ADDENDUM #4

Bid #18-01- McHenry County Government Center Parking Lot Improvements due January 23, 2018 at 3:00PM (CST)

Additions & Clarifications to BID/RFP

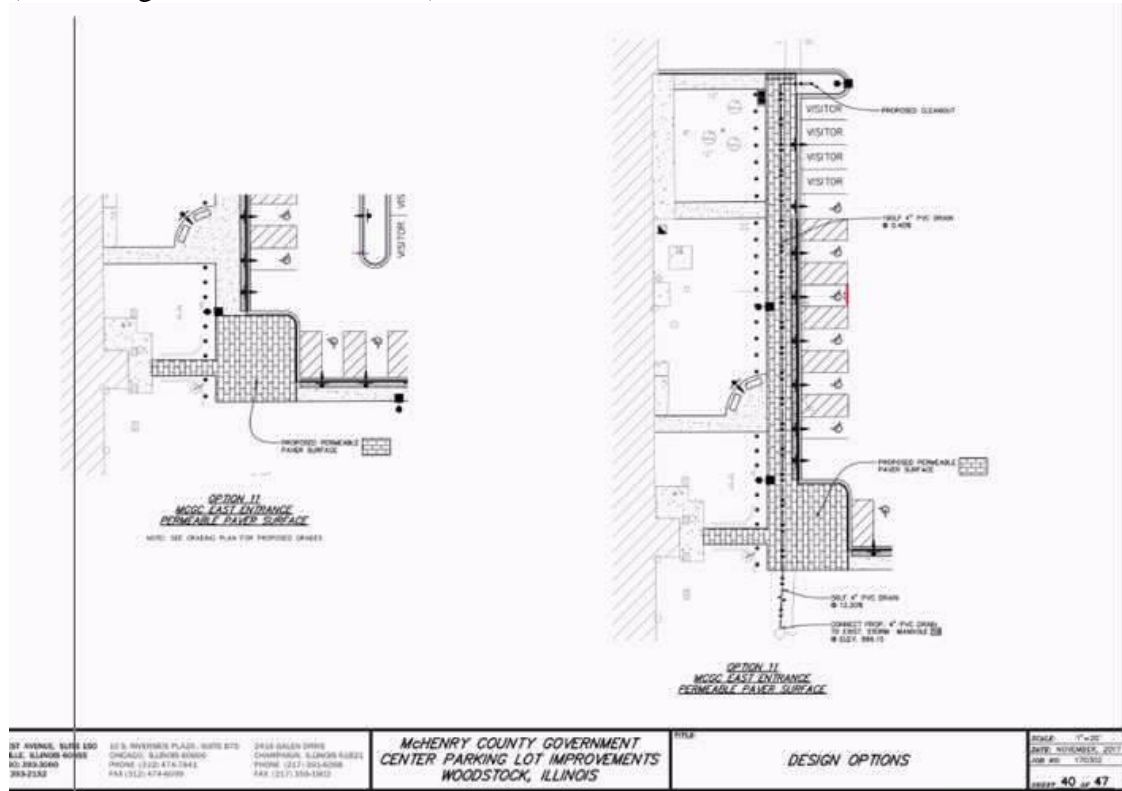
Also, for option 11 (sheet 40), the east entrance is shown differently in two different diagrams (bottom right and bottom middle). Which of these is correct? See below.

The design shown in the bottom right diagram shall be followed for Option 11.
